# Memorandum

Re: Soundview Drive NE RUE

#### **DRAINAGE PLAN RURAL AMERICAN / DUERR DAY REASONABLE USE EXEMPTION**

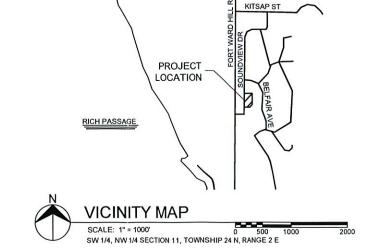
We have reviewed the City's Notice of Incomplete Application, in particular the Drainage Plan Revisions portion. The City requested that we consider low impact development methods to reduce the impact of the proposed project. Low impact development methods are a set of practices that when implemented infiltrate or evapotranspirate runoff to mimic the natural condition. In this particular case permeable soils on the site are very shallow and in some instances do not exist. Because of this rainfall on the site quickly turns to runoff and flows towards the wetland to the east. Since the soils are not permeable opportunities to infiltrate runoff from the roofs is very limited. For this reason we did not view low impact methods that rely on infiltration as feasible.

In fact the use of pervious pavement in this particular area would not be recommended because after rain fall events water would be stored in the water storage gravel under the pavement and saturate the low permeable native soils. The native soils would then lose their ability to resist vehicle loads and deform causing the pervious pavement to crack and fail.

When we designed our drainage system we recognized how runoff was generated on the site and how it sheet flow across the site. We attempted to mimic this condition to reduce the impact of the project. We are proposing to sheet flow disperse the driveways over the maximum length possible before it leaves the property. In addition, we are proposing to disperse the runoff from the roofs with multiple the splash pads. We believe this system best mimics the existing hydrology on the site.

We do agree that removing the existing gravel road would decrease the runoff from the site and we are proposing to does this as part of the project.
